Subject: Callaway Plant, Unit 1 - Amendment No. 15 to Facility Operating License NPF-30

The amendment modifies the Technical Specifications to support a transition from a Westinghouse 17x17 low-parasitic fuel assembly fueled core to a Westinghouse 17x17 optimized fuel assembly fueled core.

AMENDMENT TO FACILITY OPERATING LICENSE

Amendment No. 15
License No. NPF-30

**FIGURE 2.1-1
REACTOR CORE SAFETY LIMIT - FOUR LOOPS IN OPERATION**

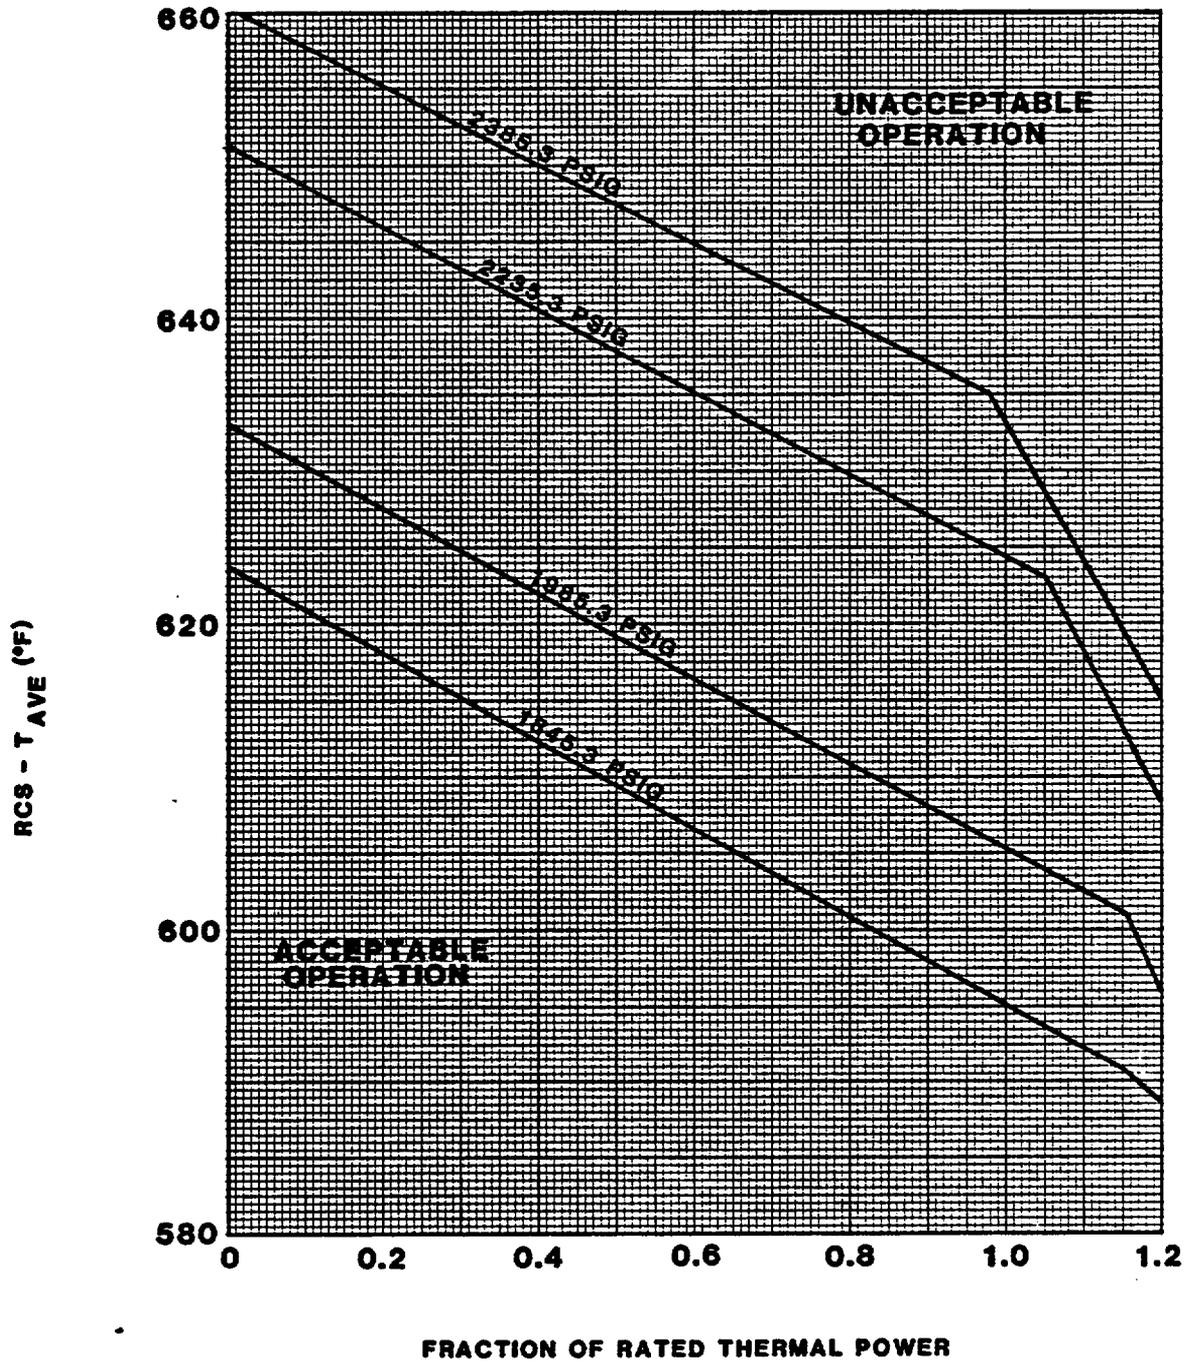
Figure 2.1-1 REACTOR CORE SAFETY LIMITS

This figure was revised to reflect the use of the ITDP and the Design Thermal Power. These are consistent with the values used in the safety analyses and are acceptable.

FIGURE 3.1-1

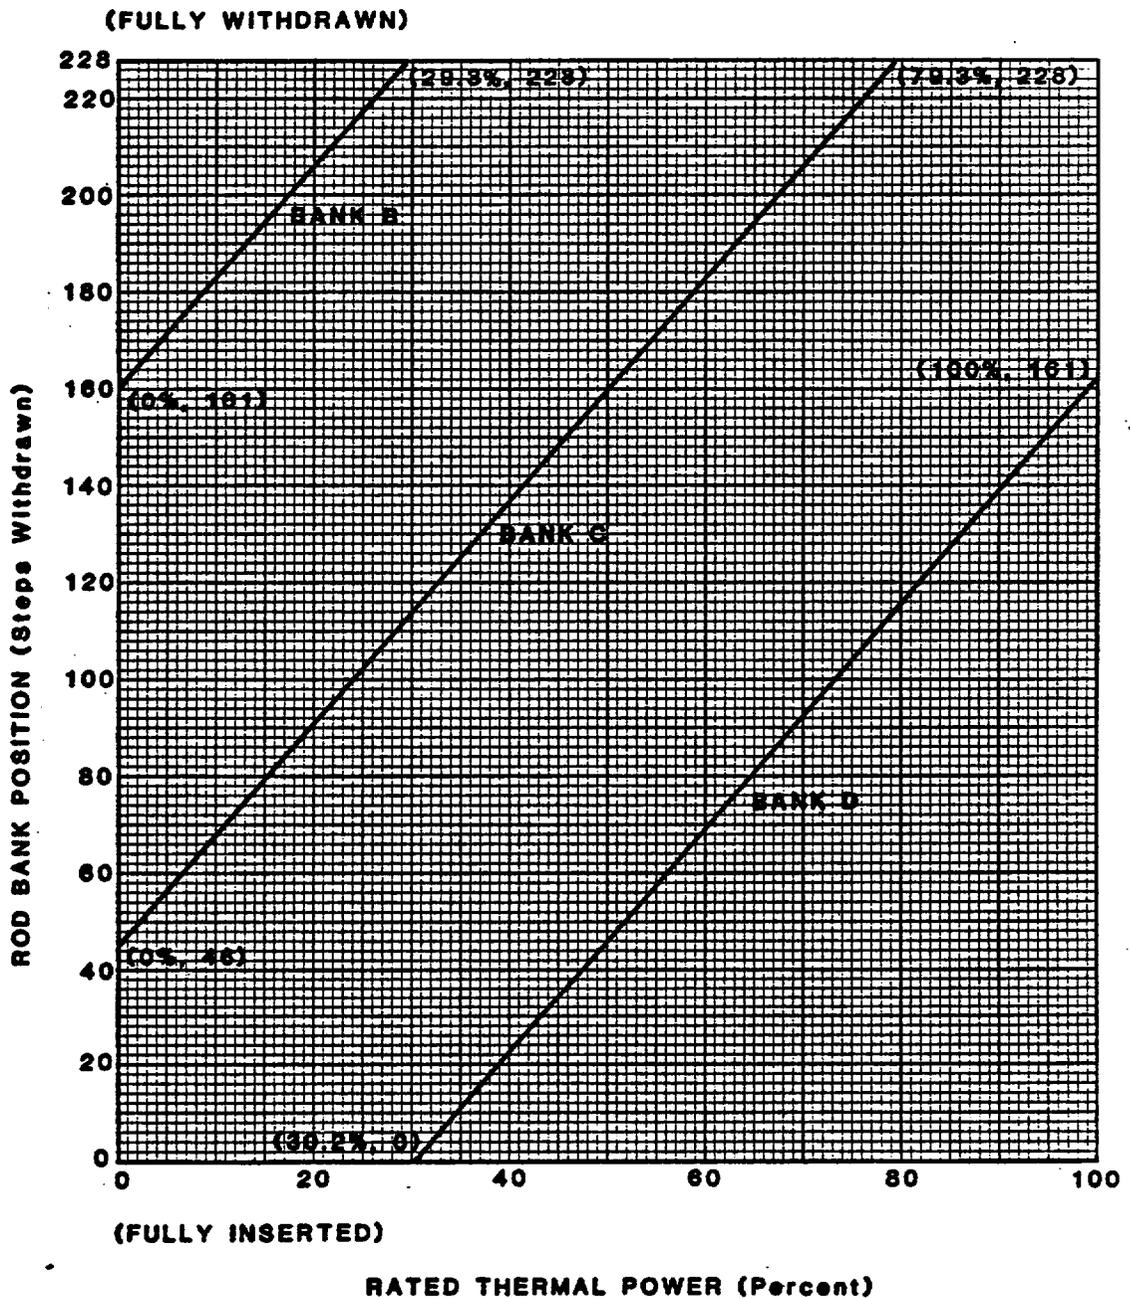
Figure 3.1-1 ROD BANK INSERTION LIMITS

The change from "Relative Thermal Power" to "Rated Thermal Power" is for clarification and is acceptable.
